**Subject: Zoning By-Law Amendment – 393 McArthur Avenue**

**File Number: ACS2023-PRE-PS-0097**

**Report to Planning and Housing Committee on 16 August 2023**

Document 5 – Site Plan

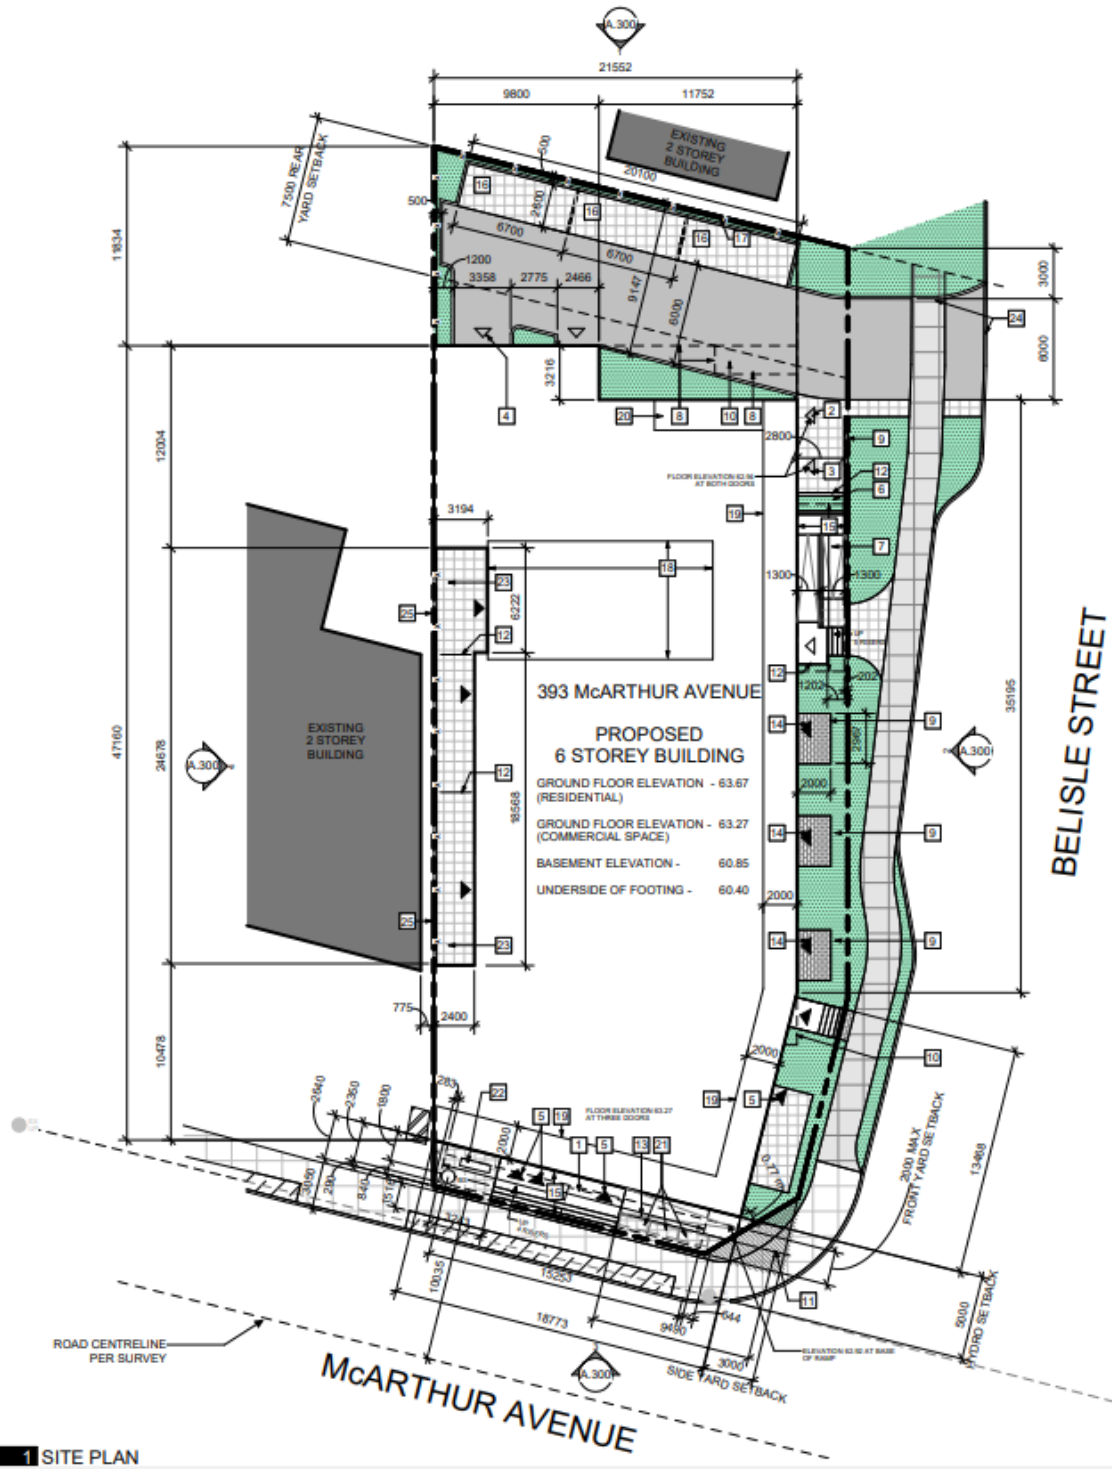
Staff are recommending an increased interior side yard setback of 2.4 metres for a portion of the western building façade, as shown in the building design in Document 5. Staff and the UDRP had concerns with the proposed treatment of the western building façade and the separation provided between the building face and the west side lot line. The increased interior side yard setback ensures that a viable outdoor amenity space is provided at-grade and provides better separation and sunlight exposure for west-facing dwelling units. All other parts of the building, not impacted by the recommended zoning provision (Document 2), may be setback 0 metres from the west side lot line as per the TM Zone.
